Re: 1510 Religious Street

Permit Number: 26-08766-HDLC

Description: Applicant is requesting retention of multiple deteriorated items and MEP systems at a Landmark, commercial building, work done without a Certificate of Appropriateness.

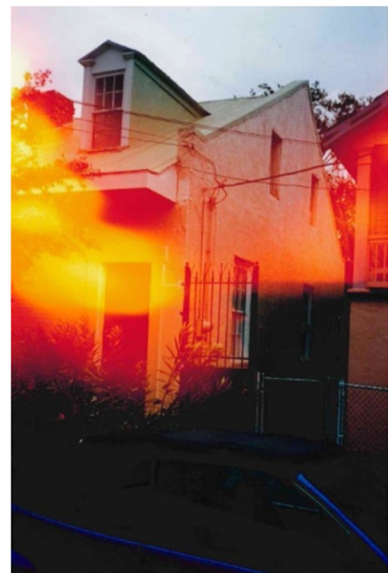
The applicant is requesting the retention of the current condition of the masonry and stucco citing the want to keep the "historic" look of the deterioration. However, the HDLC Guidelines do not allow for maintaining the appearance of delaminated stucco. Further, the brick at this building is soft "lake" brick and shows signs of delamination and missing mortar joints. While staff appreciates the aesthetic concern of the applicant, the main interest of the HDLC in this matter is the level of deterioration of the masonry.

Unfortunately, this look of deterioration has long been romantically associated with a quaint New Orleans mystique that is understandably appealing to many. However, in reality, it is the result of moisture intrusion and indicates masonry deterioration. If left unaddressed, this can lead to failure of the material which is why this is referred to as “demolition by neglect”, as can be indicated in several recent partial building collapses. Best practice, would be to repoint all of the

failing and missing mortar joints and have a new coat of an HDLC approved stucco applied to all elevations. Further, photos from the 1990s into the early 2000s show the building completely encapsulated with stucco. Staff recommends denial of the retention to maintain the current level of deterioration of the masonry and stucco and recommends that the mortar be repointed and the delaminated stucco repaired.
